DEVELOPMENT REVIEW COMMITTEE

101 S. Ocean Blvd, Pompano Hotel – Site Plan

Request: Major Site Plan
P&Z Number: 23-12000042
Owner: Claridge Homes 101 Hotel LP
Project Location: 101 S. Ocean Blvd, Pompano Beach, FL
Folio Number: 494306060690
Land Use Designation: C-Commercial
Zoning District: B-2/AOD (Business District /Atlantic Overlay District)
Commission District: 1 (Andrea McGee)
Agent: Andrew J. Schein (954-617-8919 aschein@lochrielaw.com)
Project Planner: Lauren Gratzner (954-545-7792 Lauren.Gratzer@copbfl.com)

The applicant is requesting MAJOR SITE PLAN approval in order to construct a new 220-room hotel with 1,919 square feet of restaurant space.

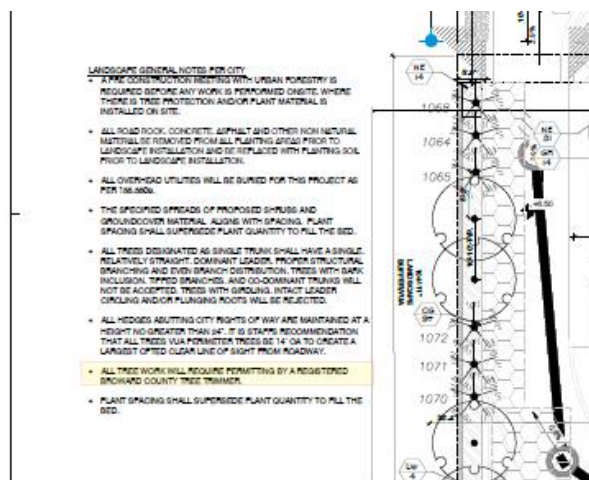
3. Provide a cross section detail of the proposed building footers / slab as it appears that it will encroach into the required foundation landscaping soil space at the footers of the building. Provide drawings and verification of the use of monolithic / eccentric footings as it relates to these areas. AR-004 appears to be on dumpster wall cross sections only.

RESPONSE: See detail 2 on sheet AR-004. This will be the typical wall section detail for East, South and North condition at the buildings perimeter. Eccentric footings will be used and strapped back to interior building footings.
